**Variation 1 to the Porirua Proposed District Plan and Plan Change 19 to the
Operative District Plan
Statement of evidence of Graeme Robert McIndoe
on behalf of Porirua City Council**

Urban Design Evidence in Reply

28 April 2023

Figure 2: Potential centre zone extension in context with overlay of 60m separation distance. Area A in red shows my proposed modification of the maximum extent of any potential centres zoning to the east of SH59. Area B is not suitable for Commercial Centres zoning.

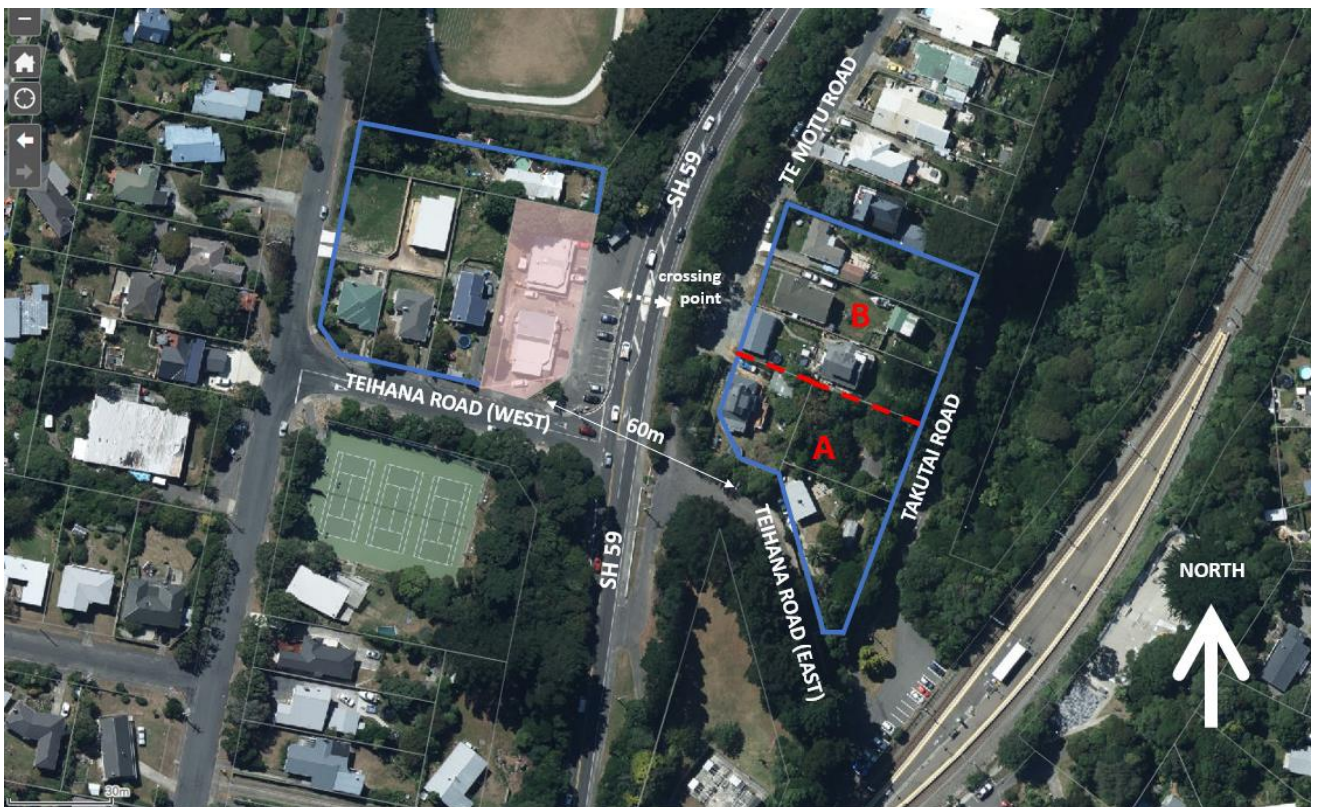
- 26 The proposed area to the east of SH59 is bounded by three local streets. It is located back from and well above SH59, with an intervening street (Te Motu Road) and therefore is unlikely to have an interface with the highway. In my opinion only the southern part of this along Teihana Road East might be suitable for any zoning change.

- 27 The lack of visibility and poor access to and past the northern part of this site to the east of SH59 in my opinion makes that northern portion (Area B in my Figure 2) unsuitable for commercial frontages and singularly inappropriate for any sort of neighbourhood centre extension.

- 28 However, considering the southern part of this site (Area A in my Figure 2) pedestrian movement occurs and can be expected to increase over time along Teihana Road East between SH59 and the railway station. That notwithstanding, access to this is not ideal. A change in level of around 1m where Teihana Road East approaches SH59 means that while there is pedestrian access up from the footpath along the eastern side of SH59, pedestrians must negotiate a change in level. Vehicle access is some 40-45 m further to the south. The 'safe' pedestrian crossing point is some 50m to the north. (Refer to Figures 3 and 4 below for images of this intersection.)

- 29 The distance between the eastern and western parts of the proposed rezoned areas can be seen on Figure 2 to be 60m. So, while these areas are on opposing sides of a state highway, (and because the traffic on SH59 will act as a divider rather than a connector) they are not especially close nor well connected. Nevertheless, assuming that railway passenger patronage increases and also that the population of Pukerua Bay increases over time, the lots fronting Teihana Road East might be developed for centres uses.

- a. this should be in combination with an appropriate package of controls; and
- b. it should be limited to Kāinga Ora's area to the west of SH59 and to the east, the area identified as A in my Figure 2.
